VIRGINIA ELECTRIC AND POWER COMPANY
RICHMOND, VIRGINIA 23261

November 7, 2022

VIRGINIA ELECTRIC AND POWER COMPANY (DOMINION ENERGY VIRGINIA)
NORTH ANNA POWER STATION UNITS 1 AND 2
SURRY POWER STATION UNITS 1 AND 2
PROPOSED LICENSE AMENDMENT REQUEST TO
REVISE EMERGENCY PLAN STAFF AUGMENTATION TIMES

STATION EMERGENCY ORGANIZATION PRIOR TO AUGMENTATION^{*}
FIGURE 5.1

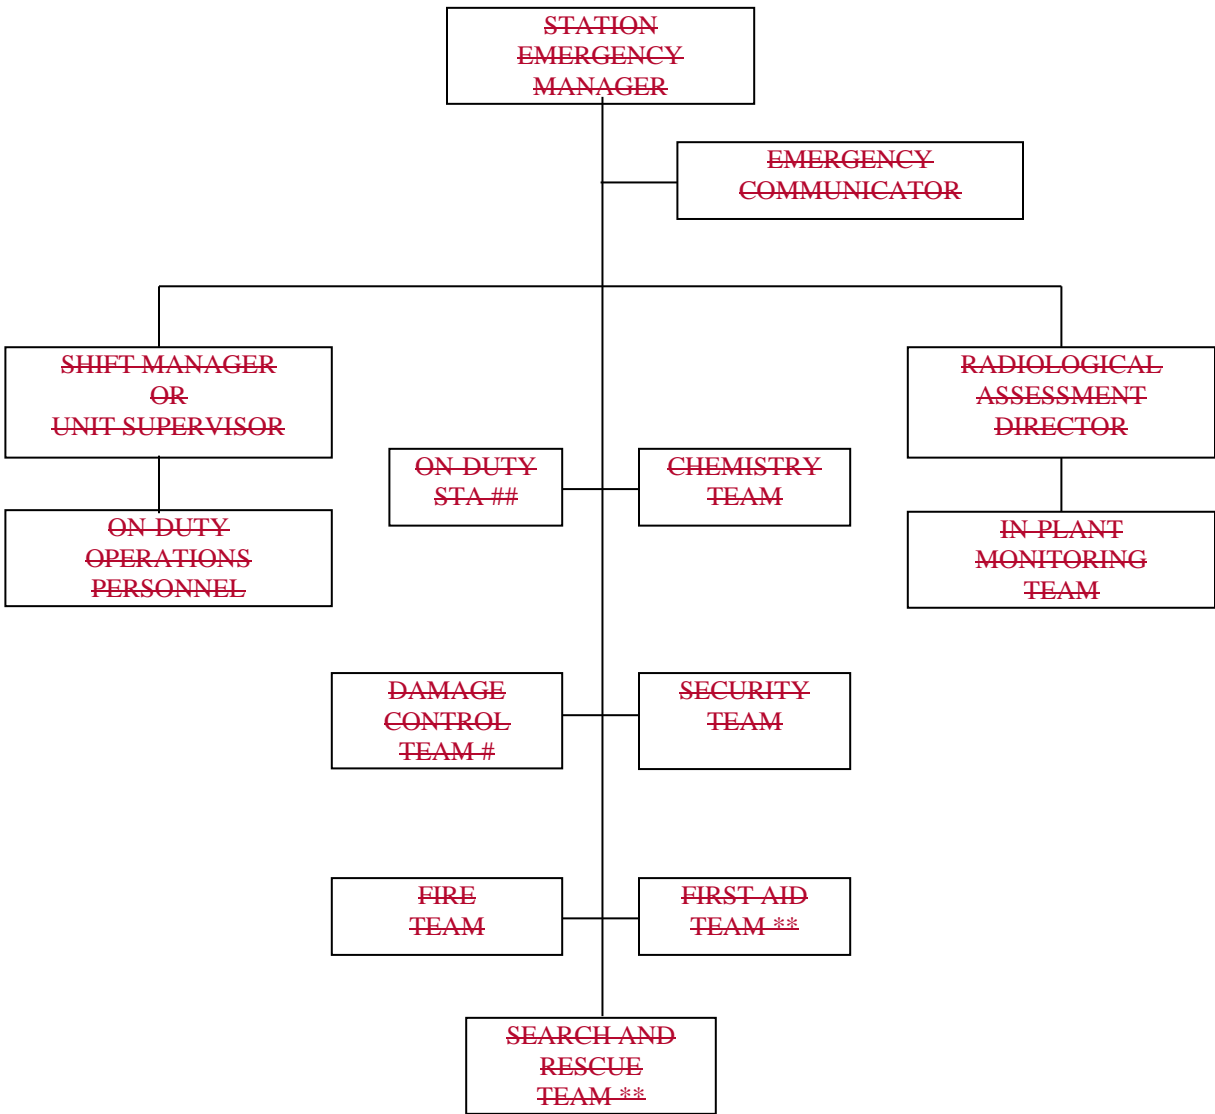
- pp. Figure 5.1, "Station Emergency Organization Prior to Augmentation," deleted figure. This figure duplicated information included in the revised Table 5.1, as well as revised Figures 5.3, 5.4, and 5.5.

STATION EMERGENCY ORGANIZATION FOLLOWING AUGMENTATION*
FIGURE 5.2

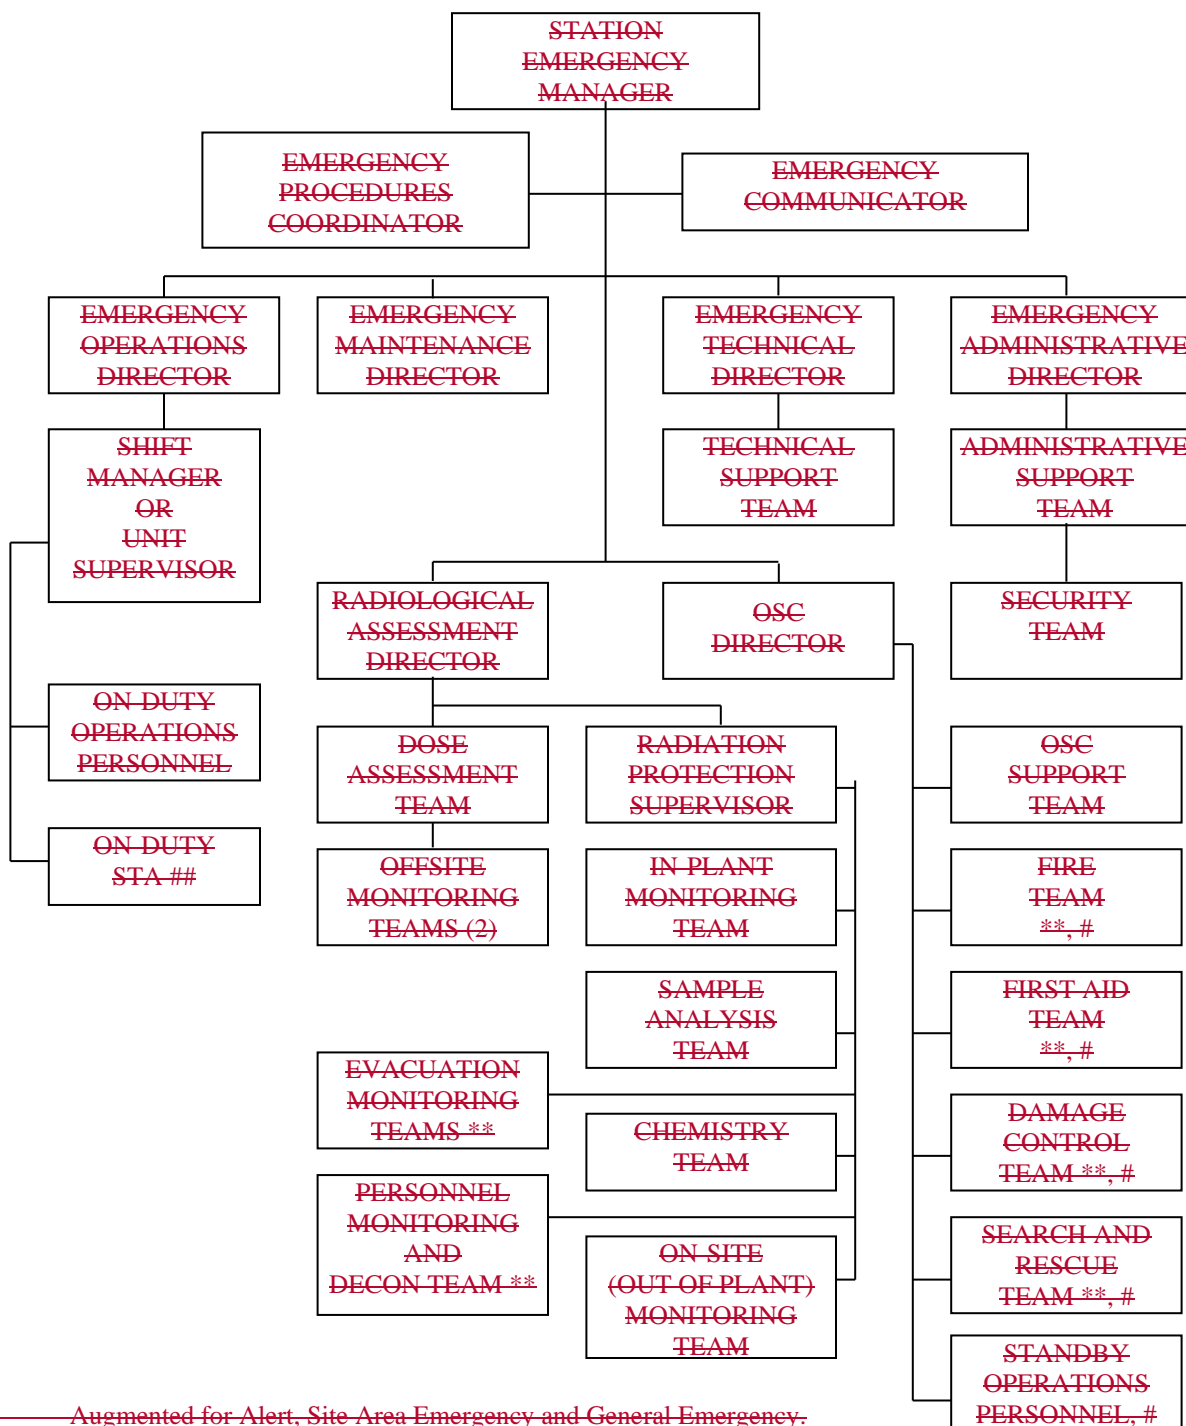
- qq. Figure 5.2, "Station Emergency Organization Following Augmentation," deleted. This figure duplicated information included in the revised Table 5.1, as well as revised Figures 5.3, 5.4, and 5.5.

FIGURE 5.13

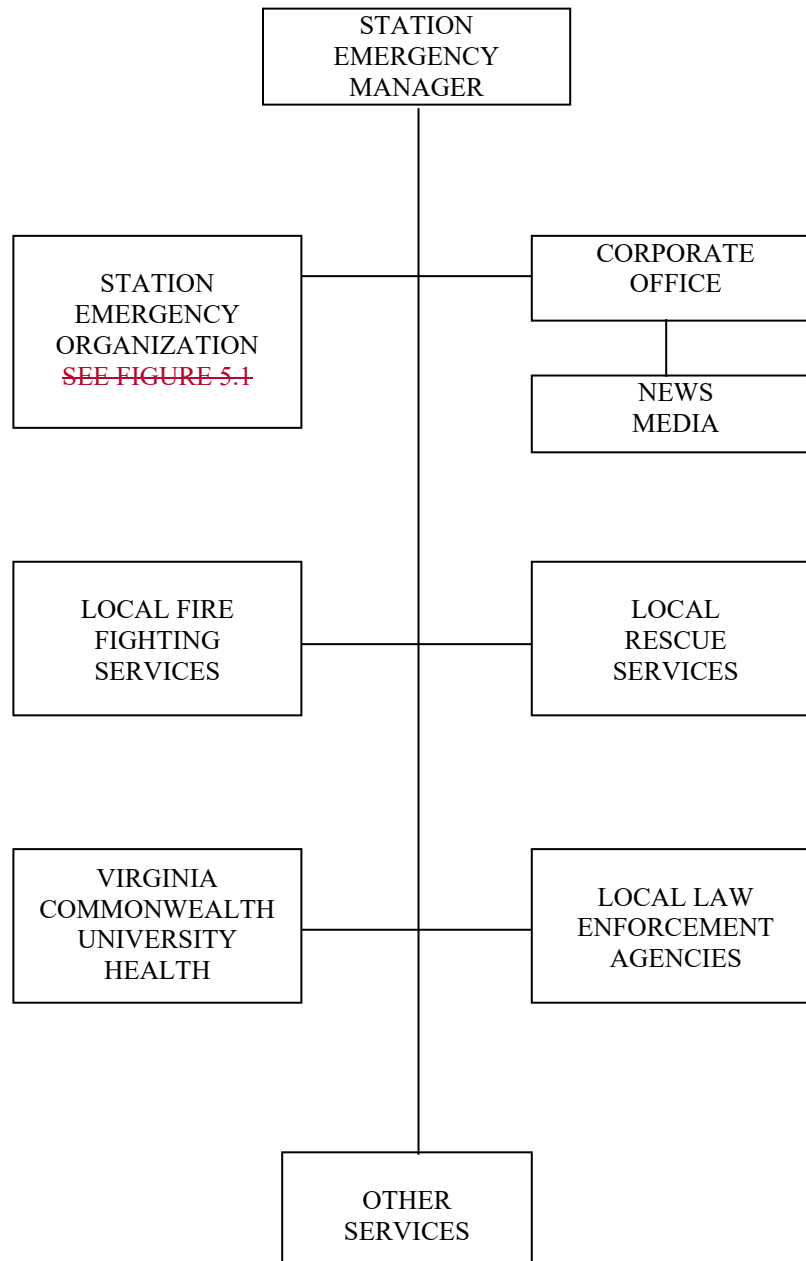
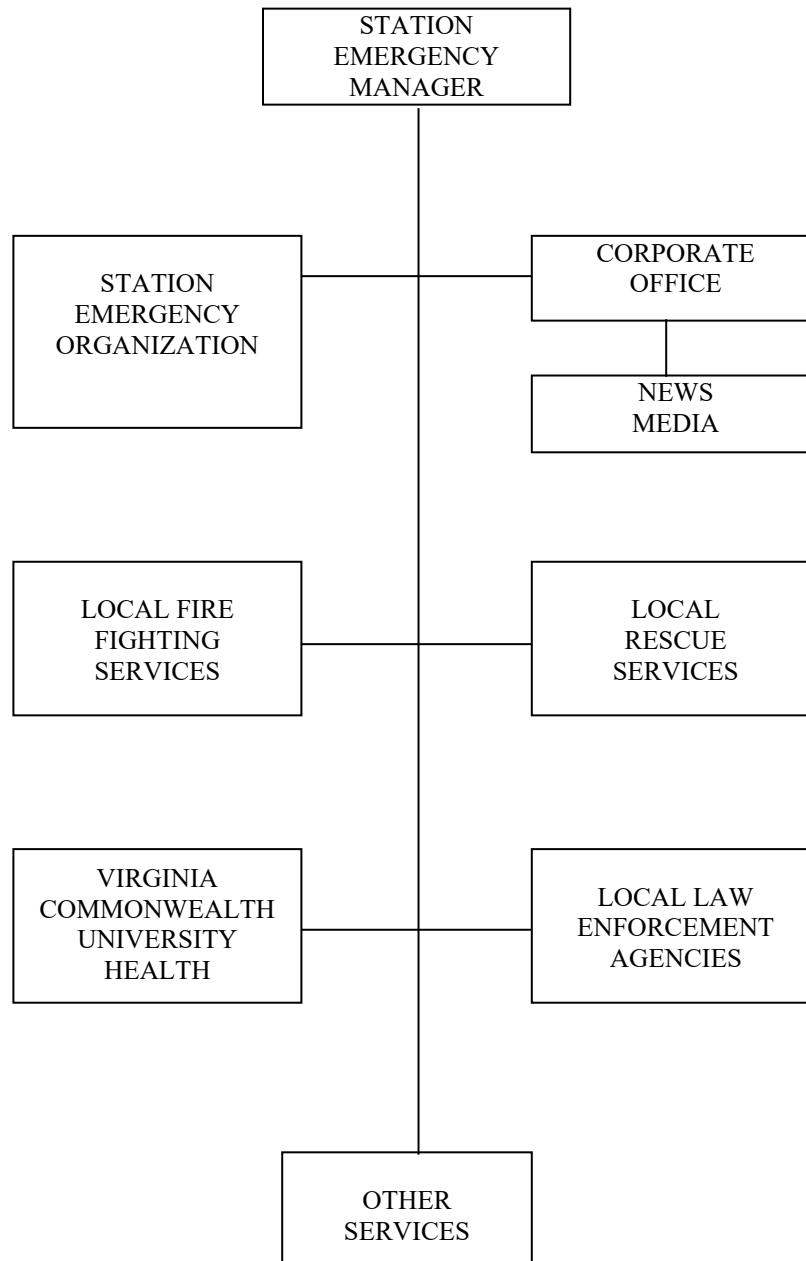
- rr. Figure 5.3, "Station to Support Group Interface Prior to Augmentation of the Emergency Organization," renumbered section and revised to reflect changes in associated figures.

STATION TO SUPPORT GROUP INTERFACE
FOLLOWING CERC ACTIVATION
FIGURE 5.24

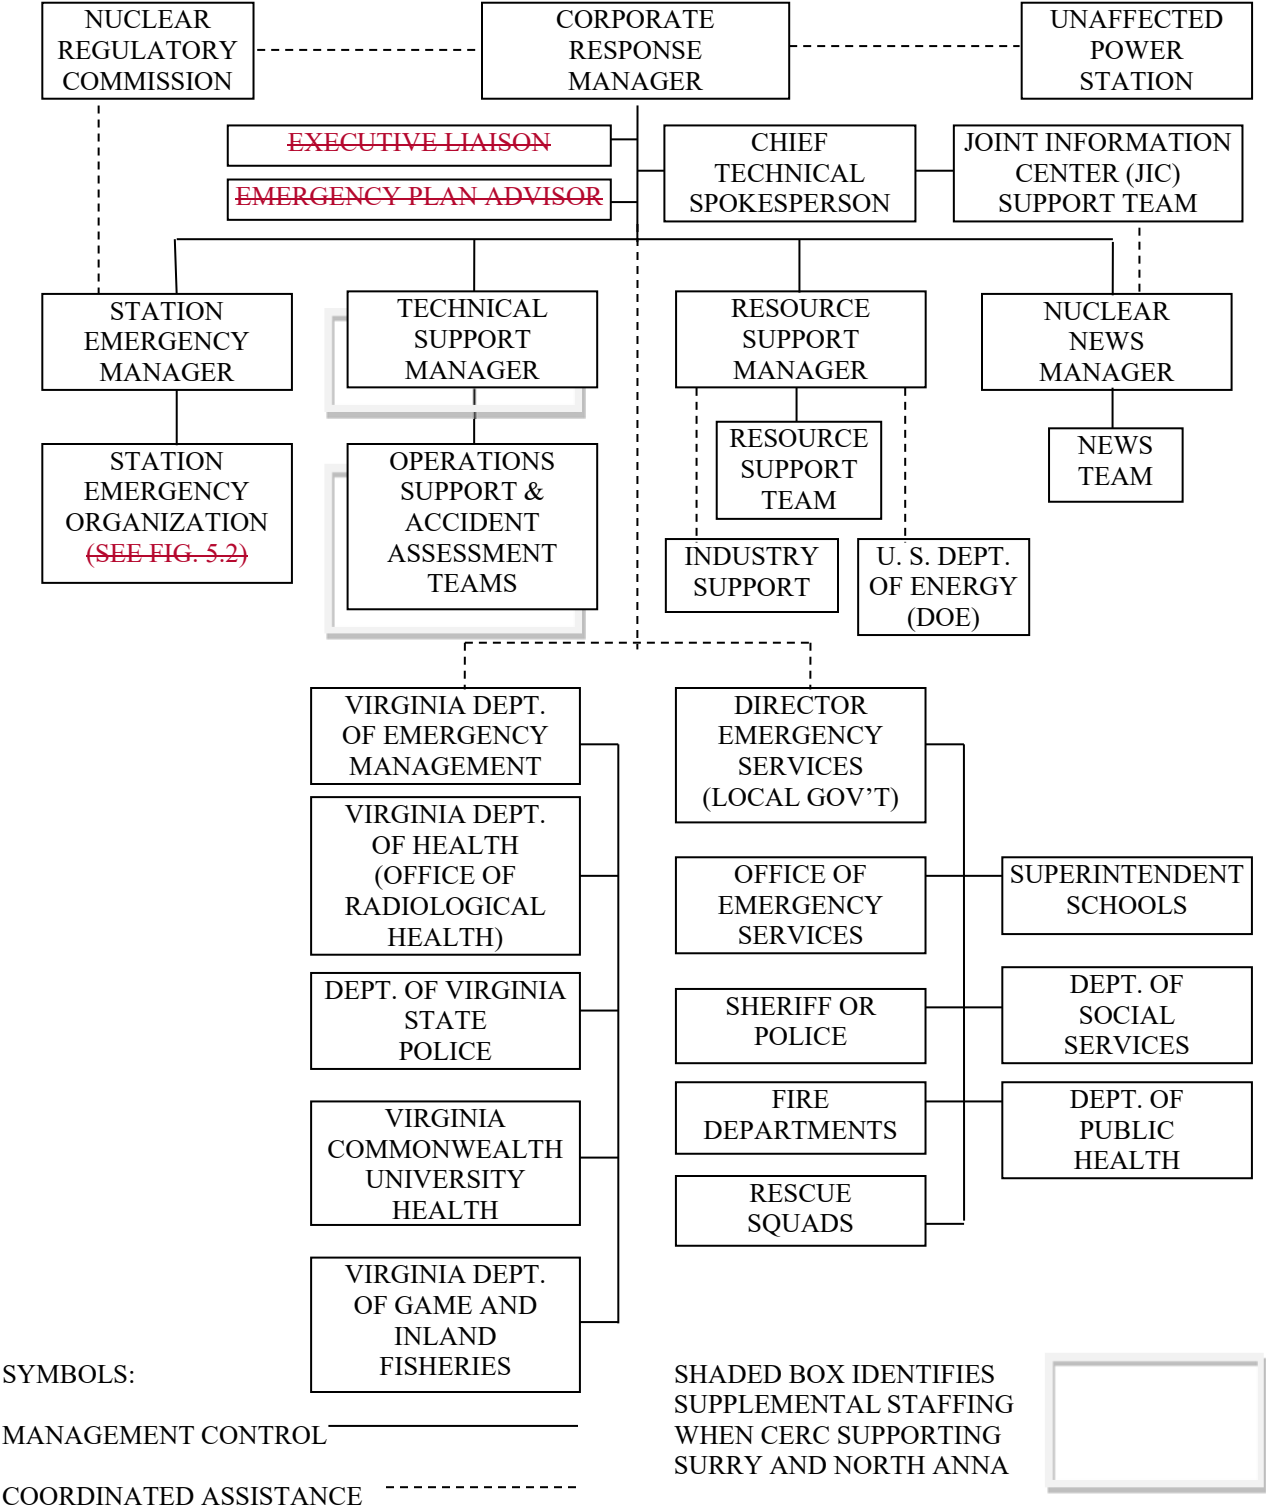
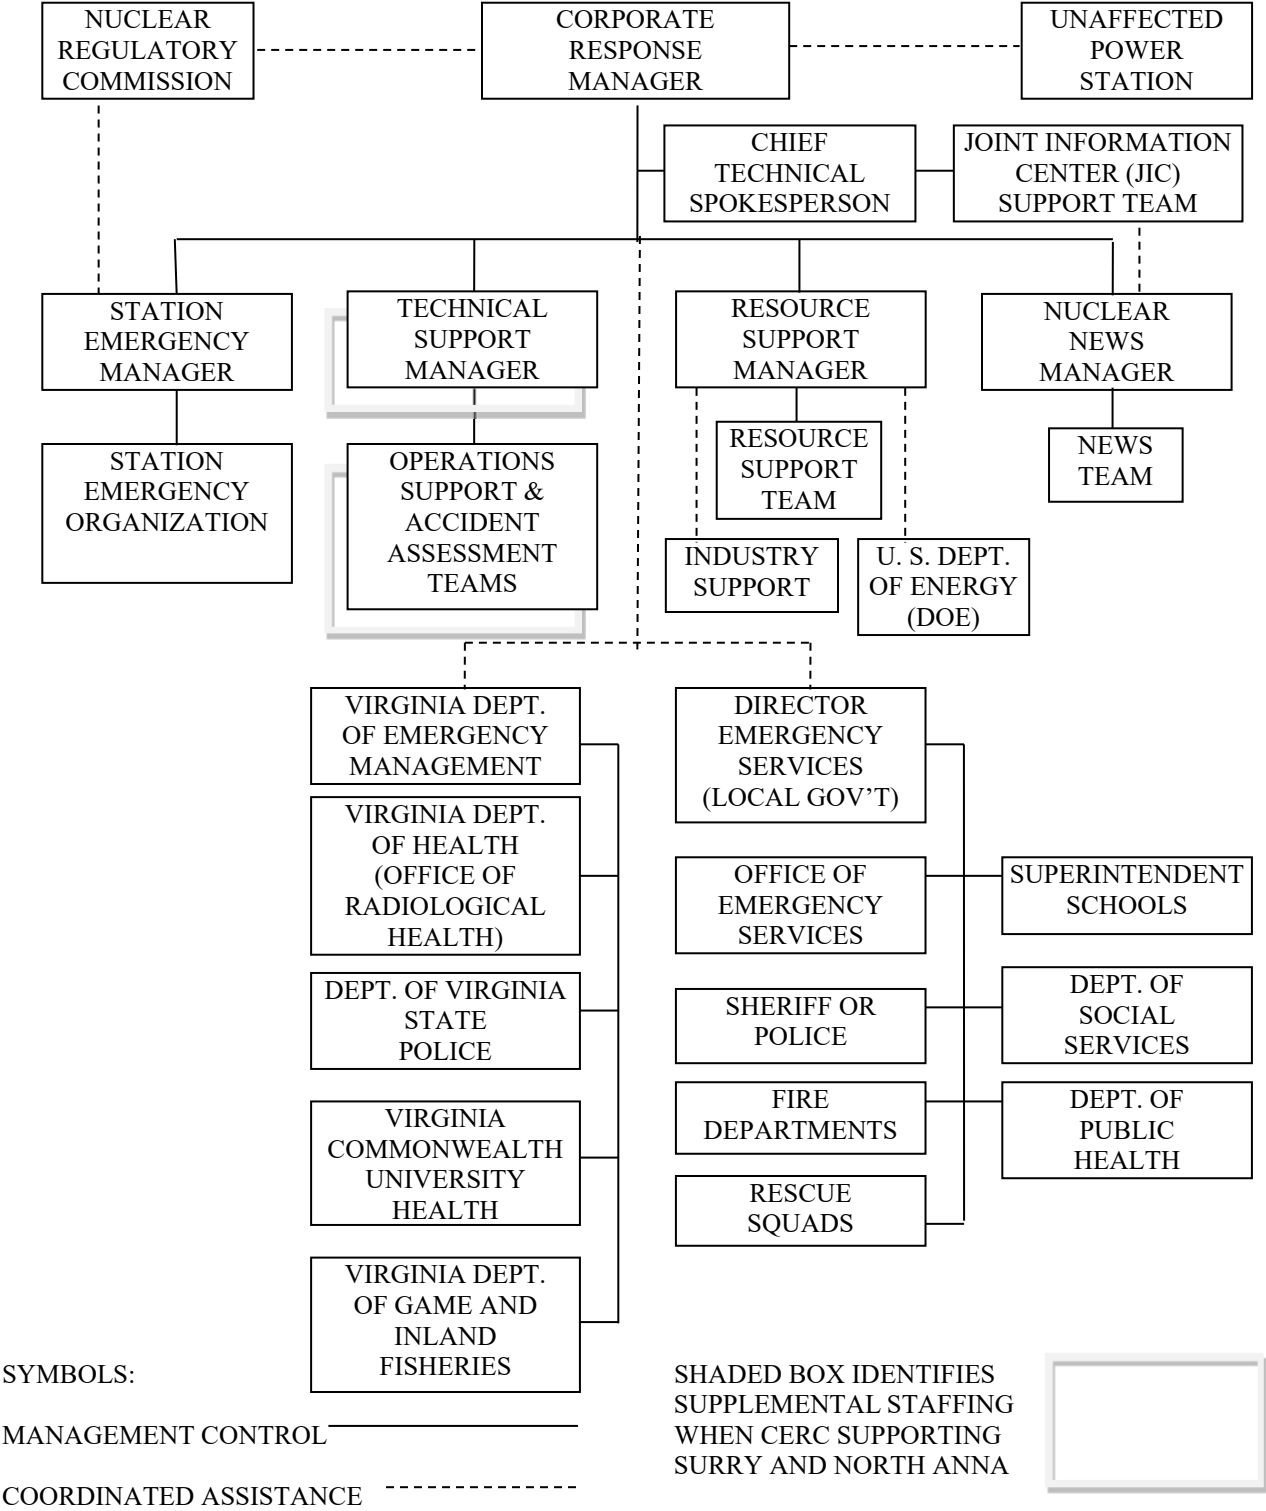
- ss. Figure 5.4, "Station to Support Group Interface Following CERC Activation," renumbered and revised to reflect new numbering, removal of administrative/support positions, and new facility organization chart numbering.
